**RE: Colowyo Coal Company L.P.**  
**Permit No. C-1981-019**  
**Technical Revision No. 144**  
**West Taylor Fill Piezometer**

Revision Description: **TR-144 West Fill Piezometer**

**To:** Brian Coates and Doug White (Colowyo)  
**From:** Samrat Mohanty (AAI)  
**Date:** October 29, 2020  
**Subject:** Geotechnical Evaluation of West Taylor Fill Piezometer

Figure 3. West Taylor Fill Piezometer Water Level Trend Since Installation

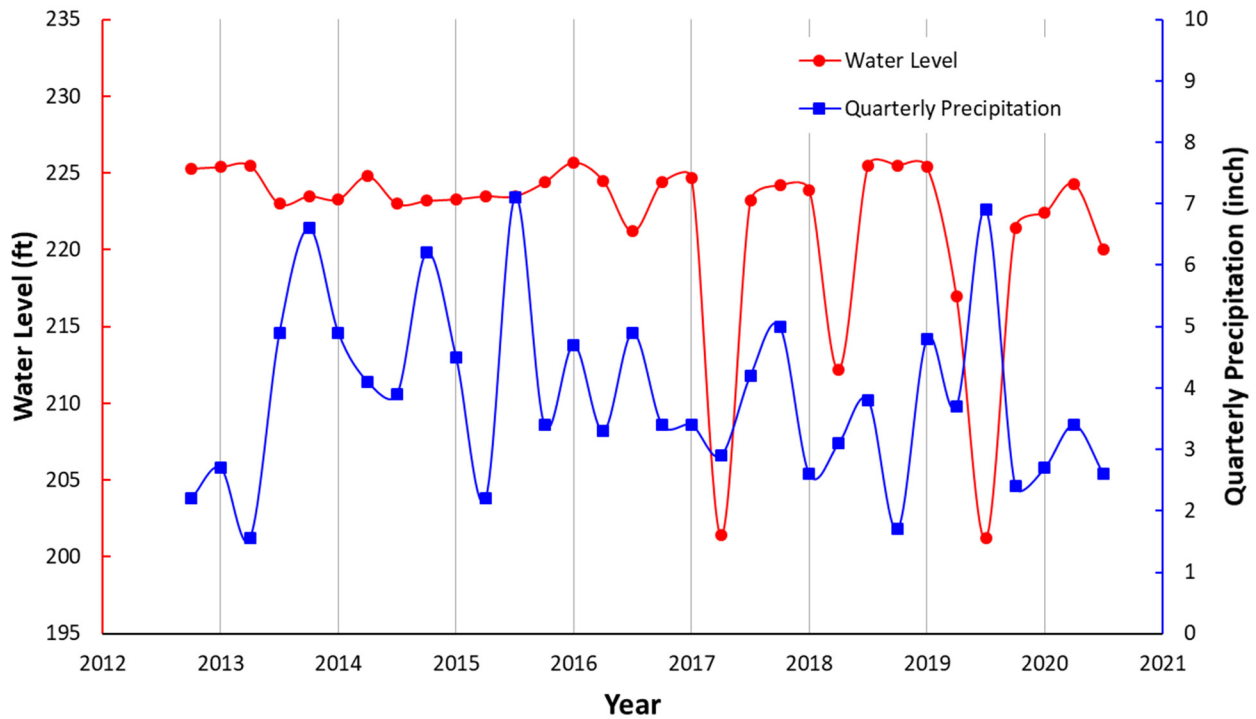
Since the first monitoring data collected in 2012, Colowyo recorded the water levels quarterly until 2018 when the piezometer well started showing signs of pinching. Colowyo has reported a total of three pinch points along the piezometer column (i.e., at approximately 90 ft, 120 ft, and 170 ft bgs). The pinch points have made measurements of the water level very difficult as the inspecting personnel need to undertake numerous attempts to maneuver the well water sounder past the pinch points. Due to the recent difficulties in accessing the groundwater level in the piezometer well, Colowyo requested that AAI ascertain if continued groundwater monitoring is required. The description of the problem prompted AAI to hypothesize that the pinching may be driven by differential displacements within the spoil matrix.

In light of the data review and following the visit, AAI is of the opinion that the pinching of piezometer well column will likely get worse as differential deformation between spoil zones of varying geotechnical characteristics continues. Ultimately, the collection of water level measurements is likely to become impossible in the near to medium term. Given the ground conditions observed at the site, AAI is of the opinion that an indirect monitoring approach may be utilized, such as quarterly review of fill surface topographic contours obtained from aerial drone measurements to detect large movements. In summary, AAI is of the opinion that quarterly measurement of piezometric water level in the West Taylor Fill area may be discontinued given the data collection challenges, which can be more effectively substituted by study of remotely monitored topographic contours in addition to quarterly monitoring of general ground conditions of the fill.
